## Avon Parks – Burnett Park and Winton Meadows Park Addendum 02

DATE: Friday, February 20, 2026

PROJECT NAME: **Burnette Park and Winton Meadows Park**

The extent of this addendum is as follows:

TBM #54  
CUT "X" IN EAST-NORTHEAST FIRE HYDRANT BOLT; LOCATED ±30' EAST OF COUNTY ROAD 900 EAST CENTERLINE AND ±375' SOUTH OF HAZLETT BOULEVARD.  
ELEV: 864.07

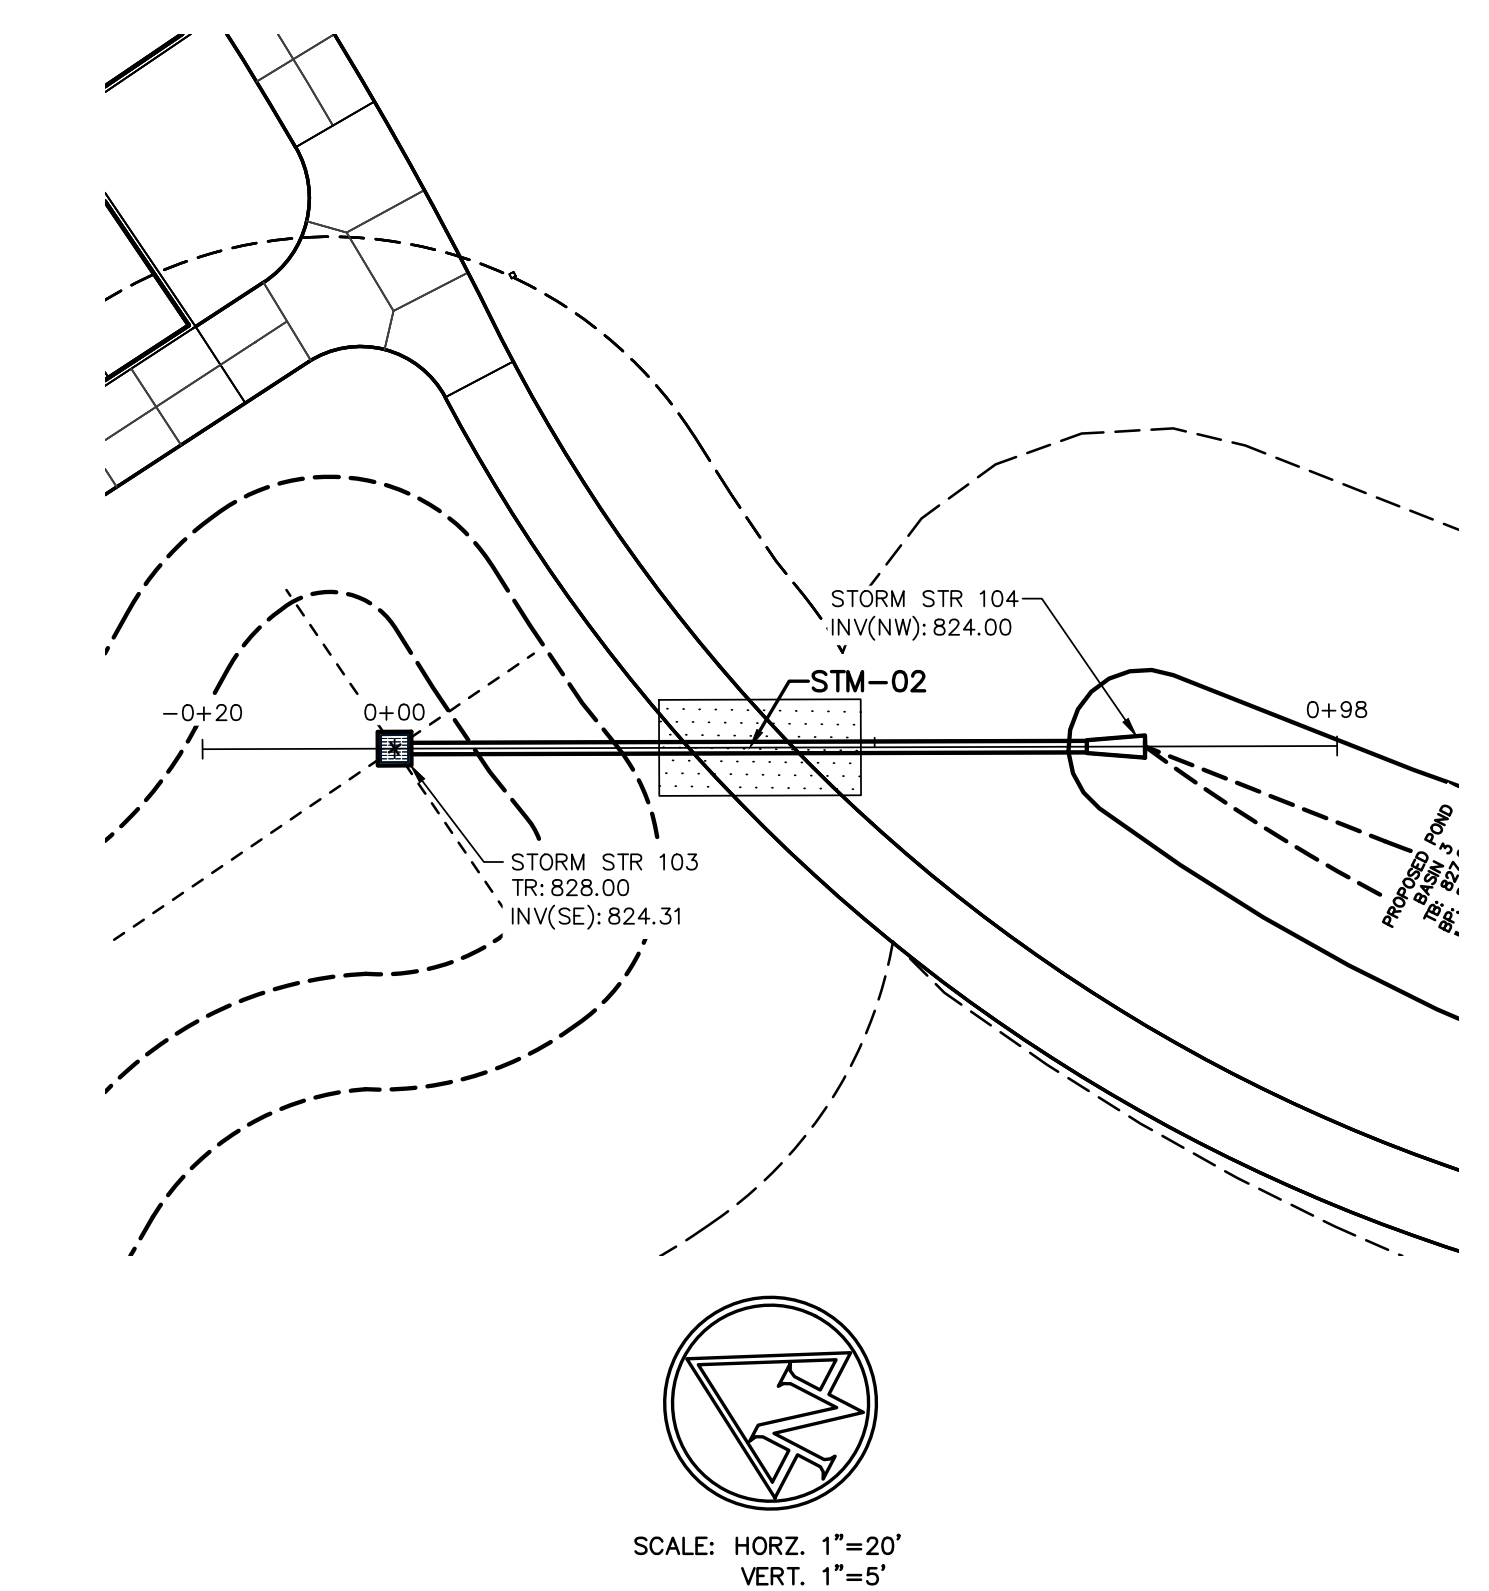
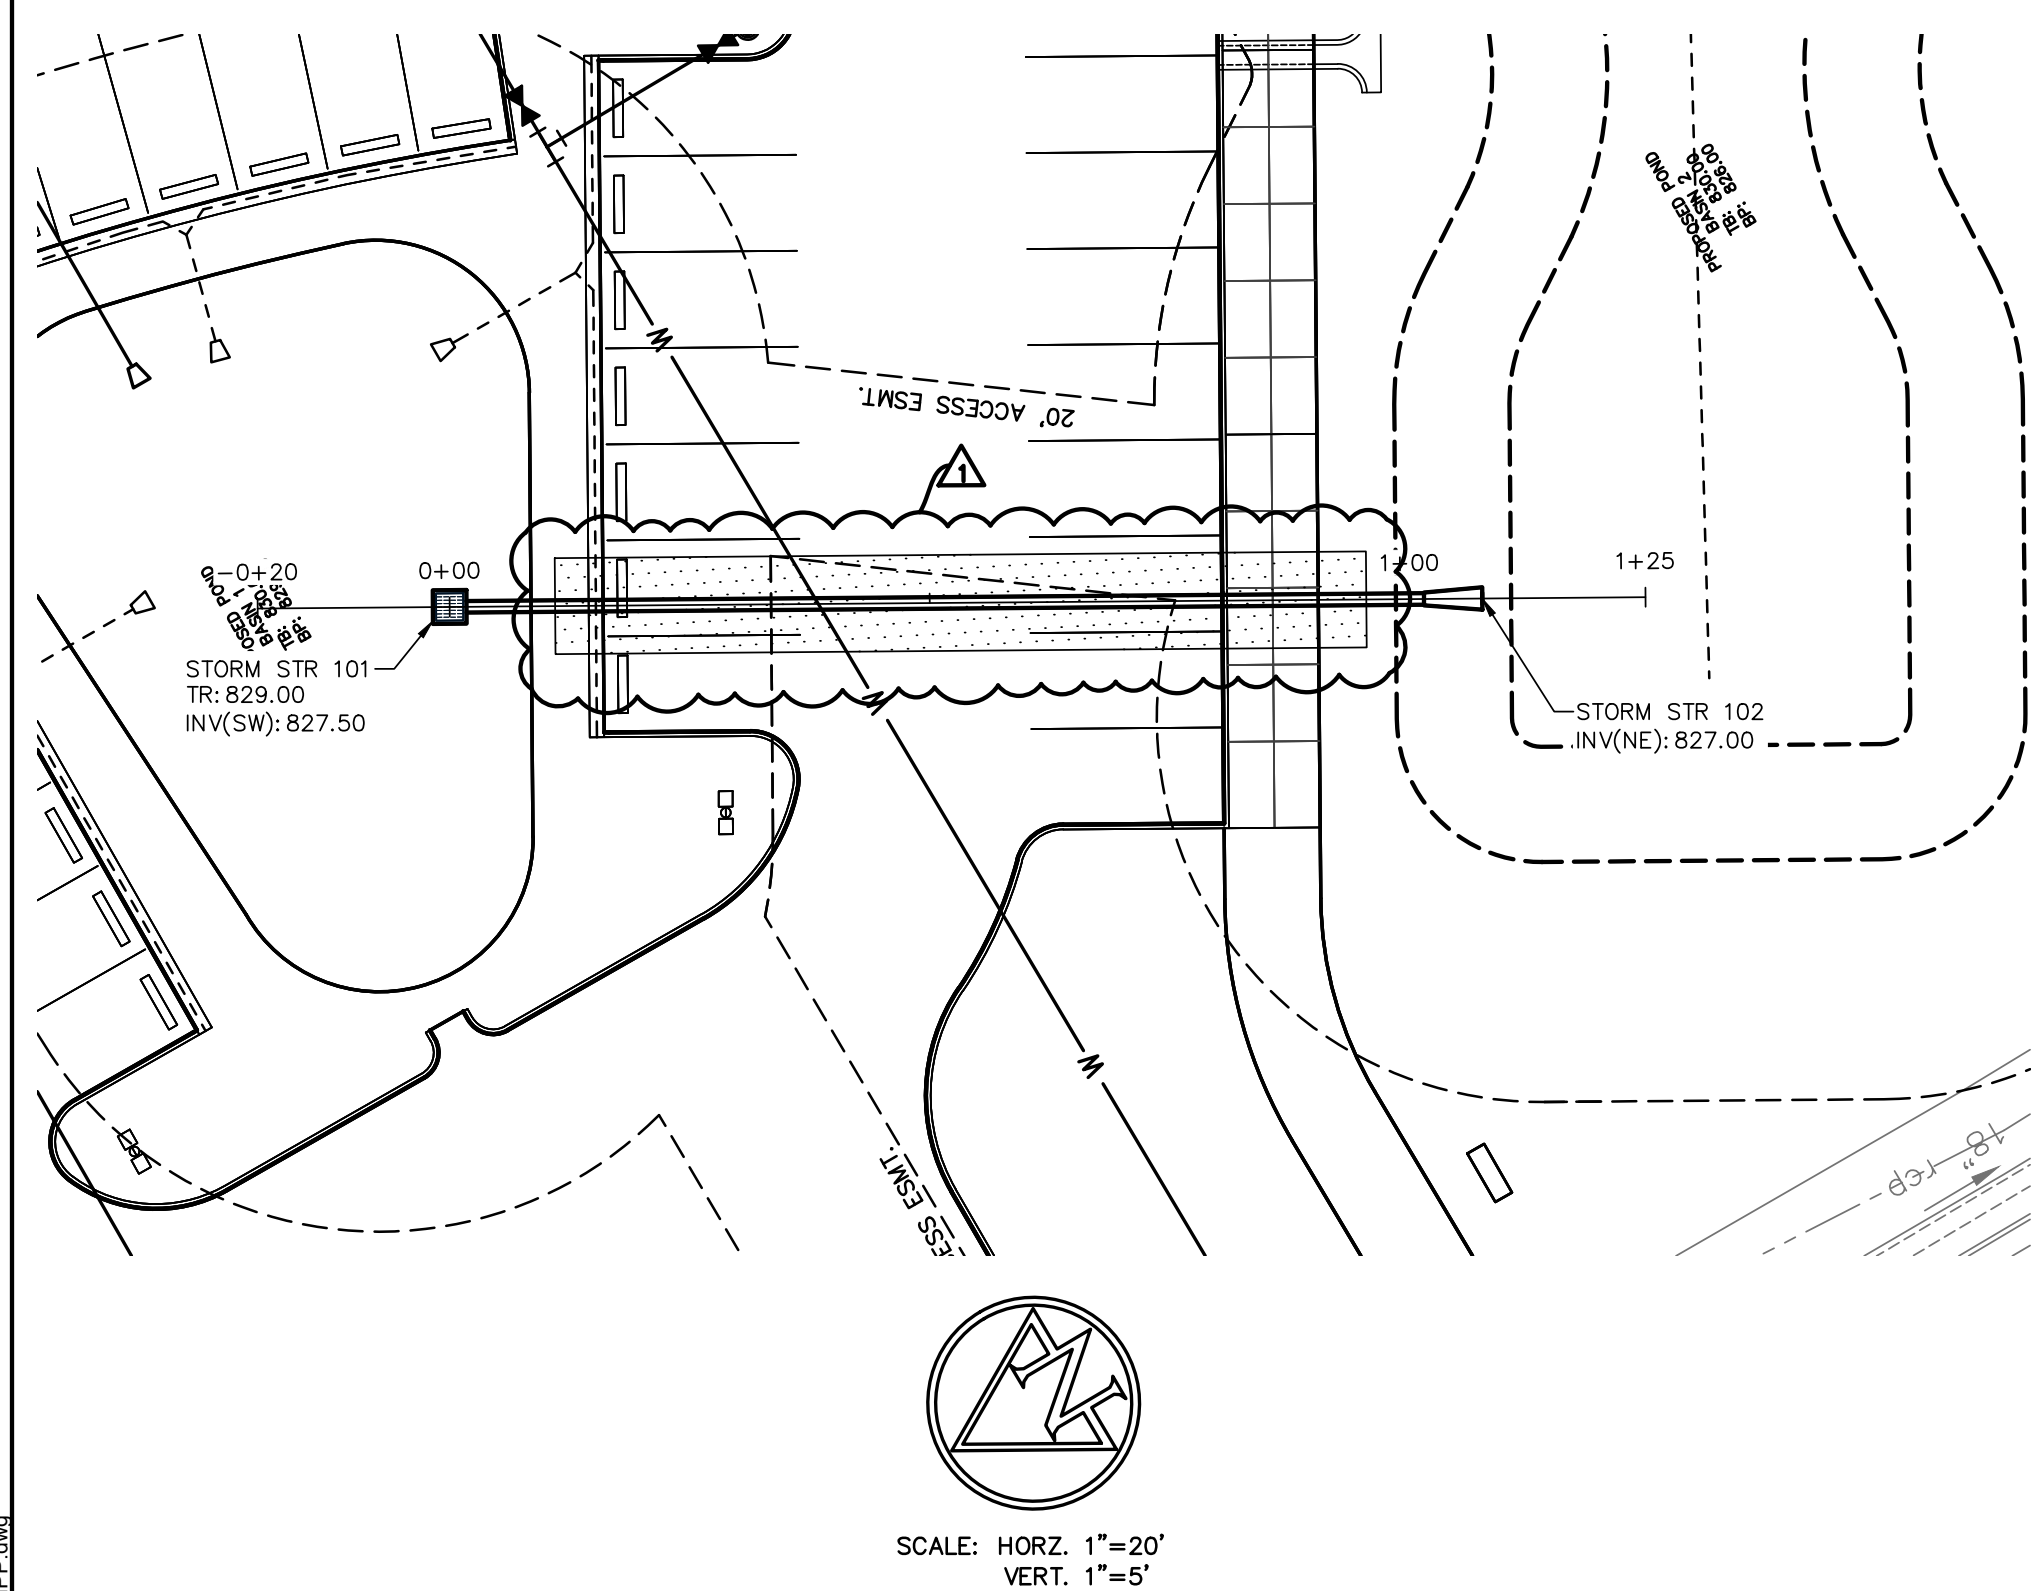
- a) STR 101 revised to inlet.
